APPLICATION

FOR PERCOLATION TESTING AND SITE EVALUATION

PERCOLATION CERTIFICATION PLAN

Re: 10865 Braeburn Drive
Braeburn Property, Lot 13
Percolation Certification Plan

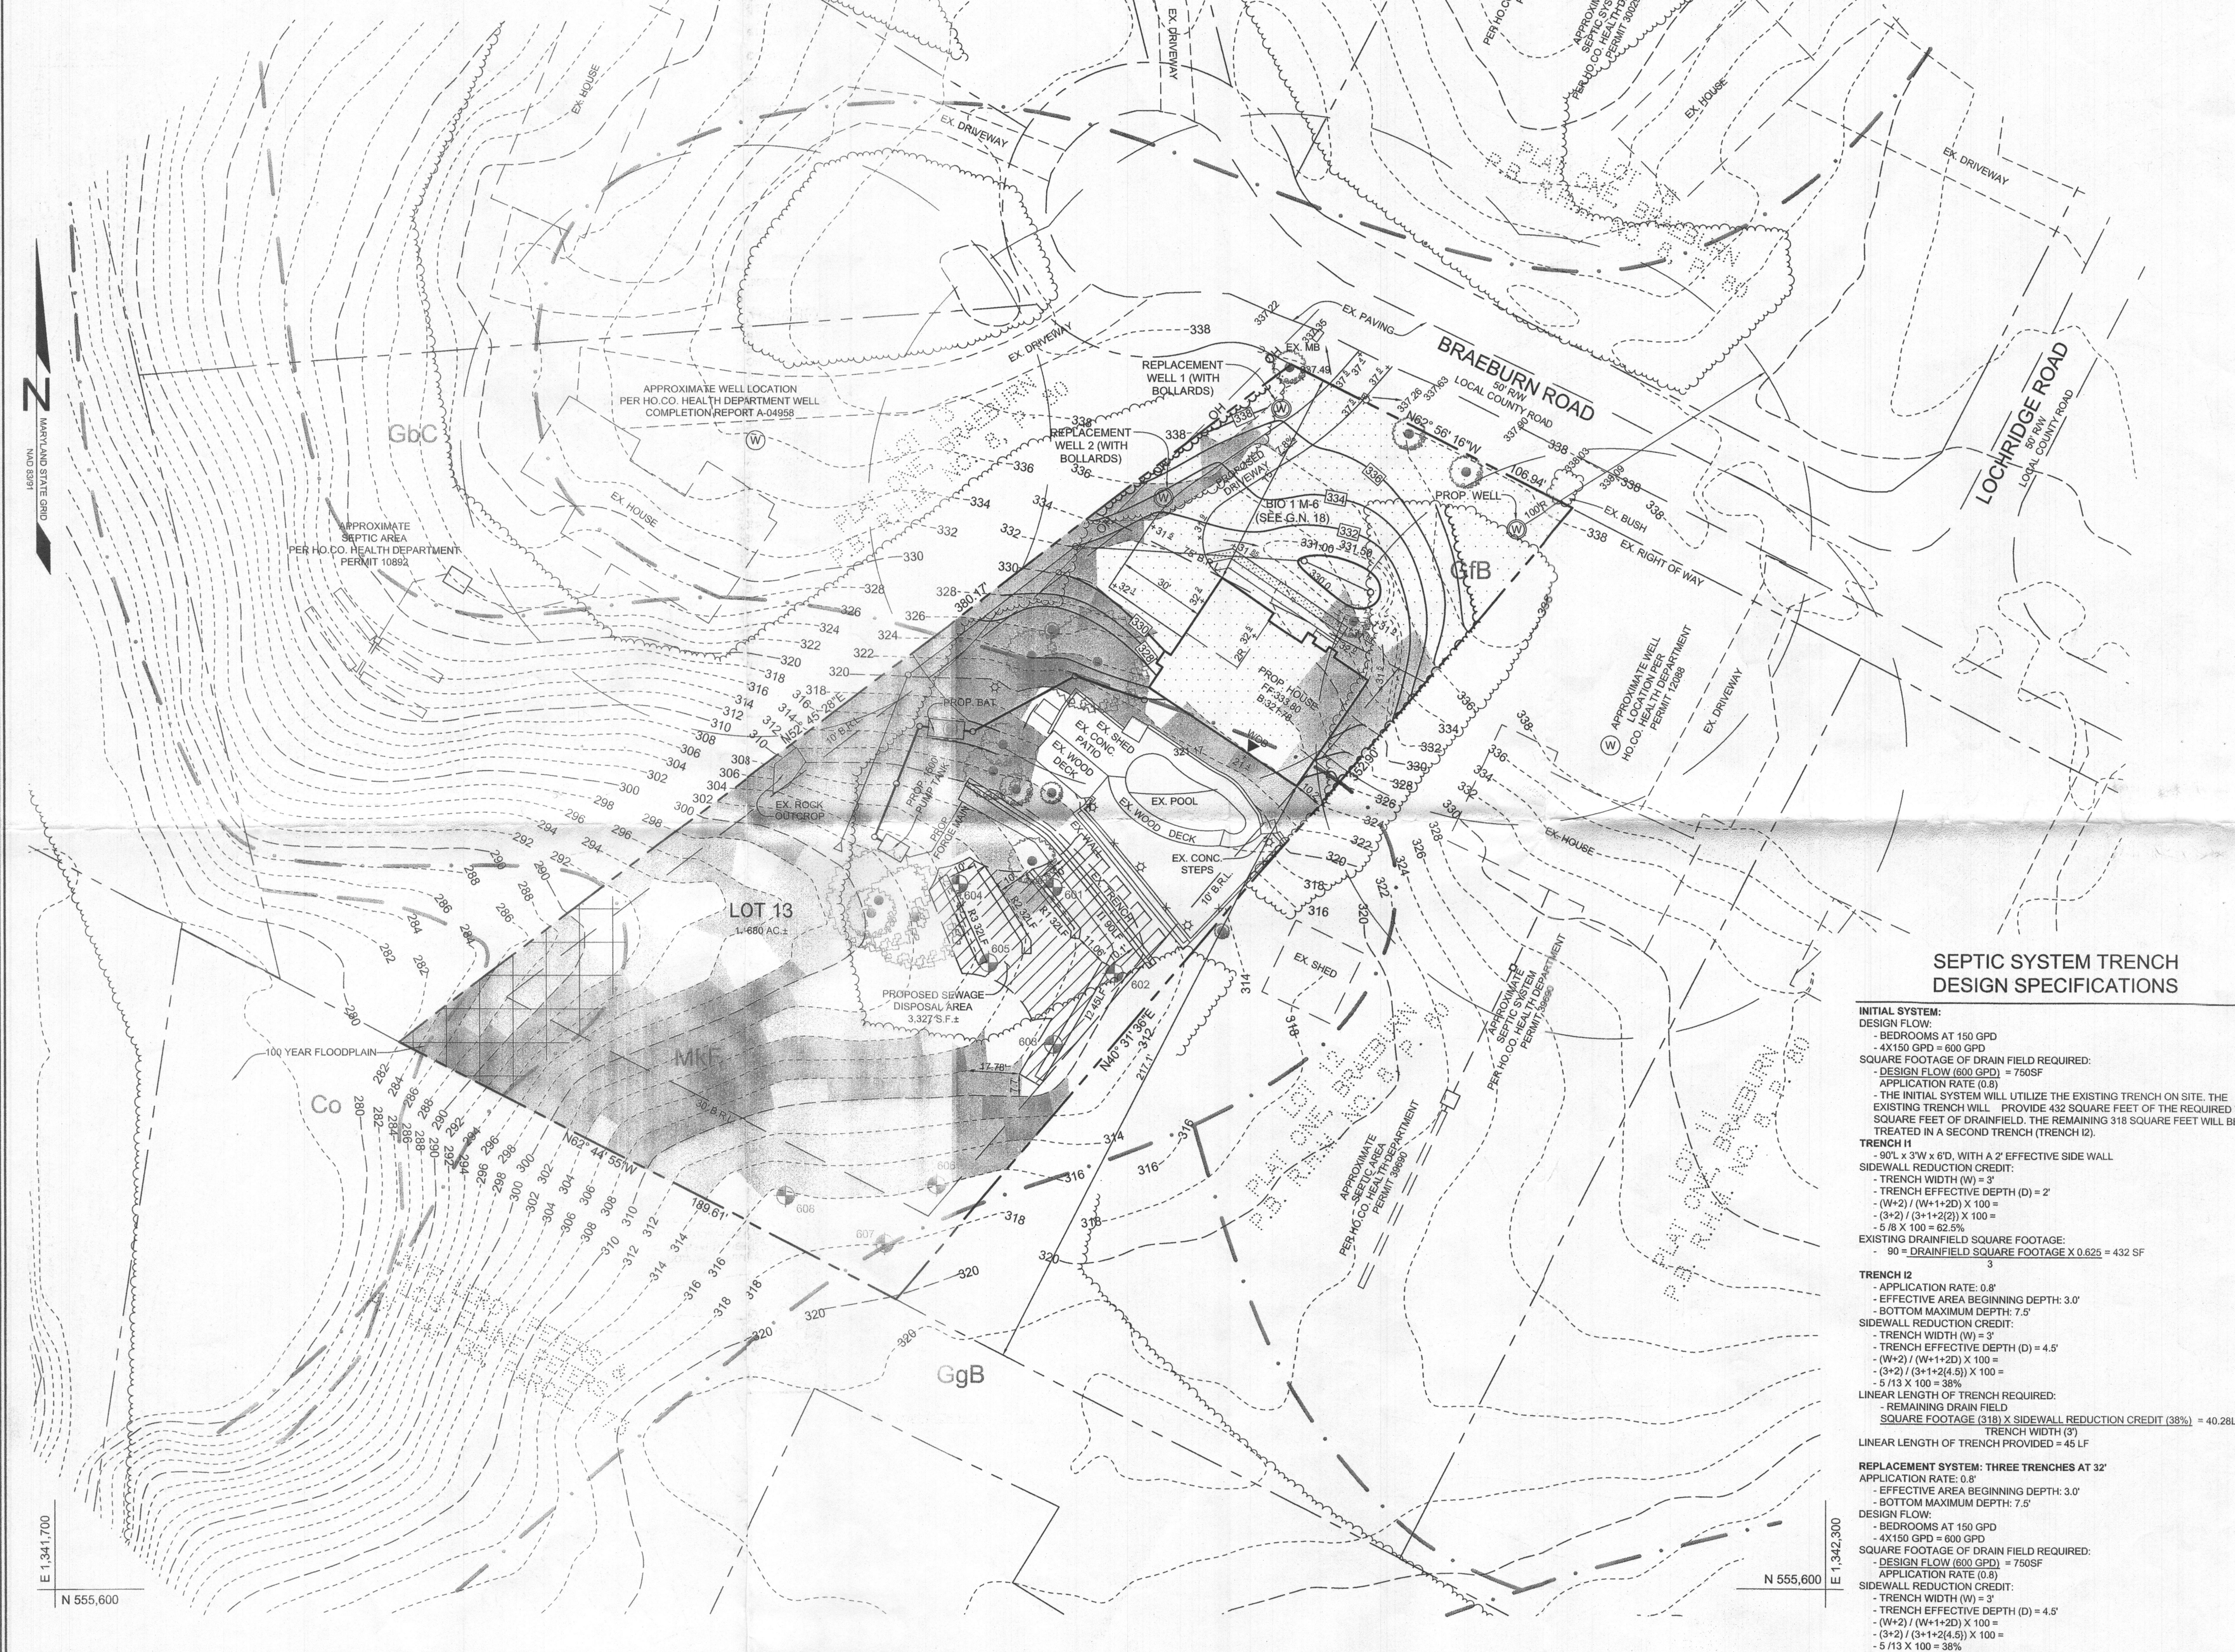
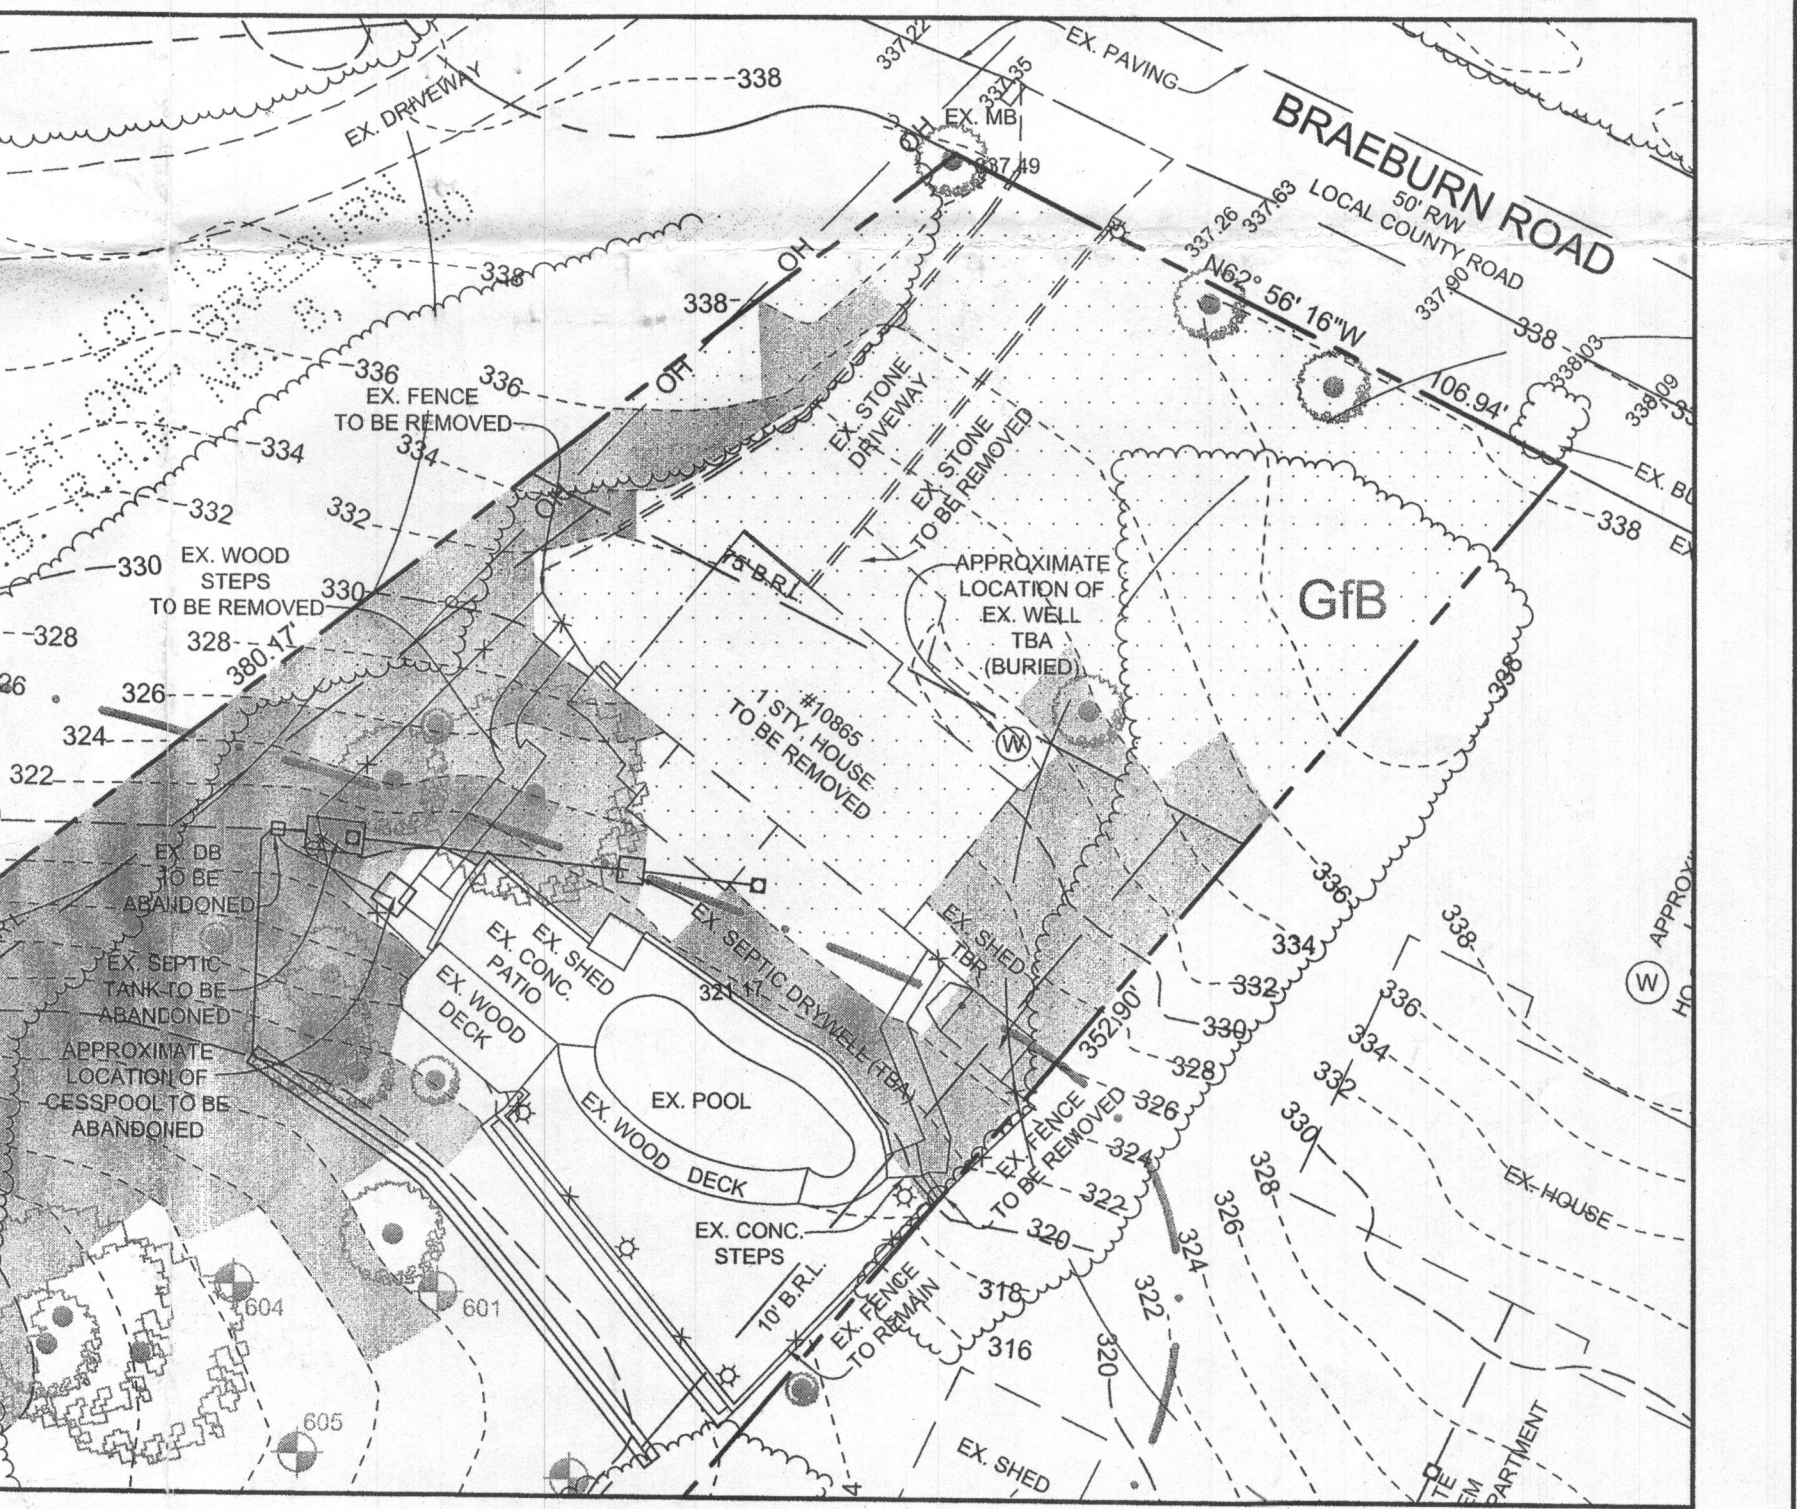
- 1.) Show a 1500 square foot well box or two alternate well sites on the plan with 100 foot well radius.
- 2.) Clarify bio-retention pond is lined (50 foot setback to a well or any proposed well locations).
- 3.) Add note, the new well must be drilled and the old well abandoned prior to building permit approval.
- 4.) Add note, a variance has been approved by MDE to allow the septic tank/pump tank to be within steep slopes.

- 1.) Show 3rd well site along driveway and property line while relocating DW. down the hill.
- 2.) Relocate pump tank so it pumps up to both systems
- 3.) Show neighboring wells and septic systems (See attachments for Lots 12 and 14)

1. Regarding the alternate well sites, please find 1 replacement well located at the front of the property, north of the proposed driveway.
2. General Note 18 has been added to the plan that states the bio-retention facility is to be lined and setback from any well or any proposed well location by at least 50'.
3. The requested well note has been added to the plan as General Note 16.
4. The requested variance note has been added to the plan as General Note 17.

1. Please see third well location along the driveway and property line. The drywell cannot be relocated downhill. There are setbacks and depth requirements that will not allow a drywell in the area downhill. The drywell has been proposed as lined and will connect to the bio-retention facility outfall as shown on the attached plans. General Note 18 has been revised to include the drywell and a note has been added to the label on the plan view.
2. The pump tank has been relocated downhill to pump up to both systems.
3. The neighboring wells and septic systems have been shown on the plan.
